TECHNICAL NOTE

Project:	Chalton Street and Churchway, London	Scheme No:	13657
Subject:	LLFA Comments Response	Revision:	01
Client:	Rangepay Ltd	Date:	21/03/2025
Doc Ref:	13657-Technical Note-01		
Author:	Jack Pugh BSc (Hons)		
Checker:	Aled Williams BSc (Hons) MCIWEM C.WEM

This Technical Note has been prepared in response to comments made by the Lead Local Flood Authority (LLFA) with respect to discharging drainage conditions for a proposed hotel at 53-55 Chalton Street and 60 Churchway, London.

ROOF LEVEL LOADING DIAGRAM SCALE= 1:200

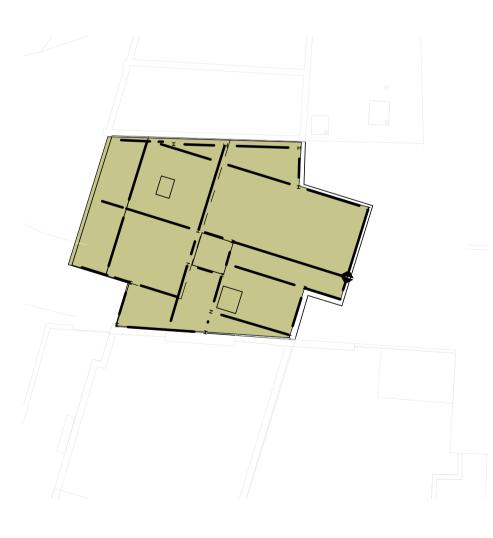
1) LLFA Comment: 'Further justification and rationale on removal of blue roof from the proposal and move to basement tanks.'

A supporting letter provided by SWAL Engineering Ltd (Consulting Structural Engineers) is included as Appendix A. SWAL Engineering conclude that the roof structure is currently designed for an imposed loading of 0.75kN/m² however, an imposed loading of 2.04kN/m² would be required to attenuate rainwater at roof level. The site is located above subterranean TfL tunnels therefore, strict control over foundation loadings and ground settlements must be maintained to prevent potential damage.

The proposal for the inclusion of a blue roof system at roof level appears to exceed the original design loading. The blue roof proposal produced by Bauder, appended to this report, indicate that a blue roof system would require an imposed loading of 2.04kN/m² to attenuate rainwater at roof level. This uplift in loading is 2.7 times increase in load. To achieve the proposed roof loadings associated with the blue roof system, significant re-design of the roof carcass and supporting structural elements would be required. This would likely result in having to remove a significant portion of the original structure and reinstate new columns and beams to resist the uplift in load. Further, the increase in load would change the distribution of the load path across the foundations which the structure has not been designed for.

Waterco Response: The suitability of blue roof attenuation has been assessed. Blue roofs are not considered feasible due to the significant risk of structural damage to the underlying tube line (due to additional loading).

In conclusion, the current structural arrangement is demonstrably inadequate to withstand the loading demands imposed by a blue roof system, necessitating substantial structural redesign and modifications to the existing as-built structure. The inclusion of such a system would fundamentally alter the structure's load path, resulting in a concentrated uplift of foundation loads. This concentration of loads would, in turn, lead to increased ground settlements beneath the foundations when compared to a loading arrangement that distributes the attenuation load over a broader area, such as the proposed relocation of attenuation tanks directly onto the basement slab. This disparity in settlement potential underscores the critical need to reconsider the blue roof system in favour of a loading strategy that minimises concentrated loads and mitigates the risk of excessive ground settlement.
